# UNITED STATES PATENT AND TRADEMARK OFFICE

APPLICATION NO.	FILING DATE	FIRST NAMED INVENTOR	ATTORNEY DOCKET NO.	CONFIRMATION NO.
10/057,509	01/25/2002	Tatsuya Hirano	4304	4330

**Office Action Summary**

## **DETAILED ACTION**

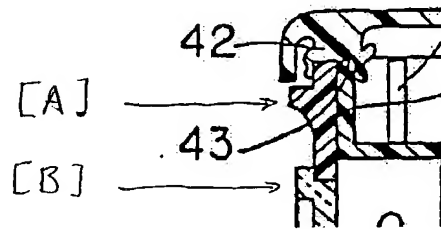
Regarding independent claim 1, EP ‘670 is relied upon to teach a battery having a thinner see-through window [6] portion provided on a sidewall of the battery casing. A reinforcing rib is

provided at said see-through window, such as the oval frame of the window [6] as shown in Figures 4 and 5. Figure 5 shows that the thickness of the battery casing [A] is equal to the thickness of the reinforcing rib [B]. (applies to dependent claim 4)

By this illustration it is considered that the reinforcing rib is a thicker portion of the see-through window. (applies to dependent claim 5) A plurality of reinforcing ribs such as partition walls [34, 35] and extending parallel to the height of the battery are provided at regular intervals for dividing the battery into a plurality of cells. (col. 9 line 25-52, applies to dependent claims 2 and 3) As to positioning the reinforcing rib "in alignment with said partition" (dependent claim 2), the ribs in EP '670 are considered to be in "parallel" alignment. The window is provided on one side surface of a rectangular-shaped battery. (applies to dependent claim 6)
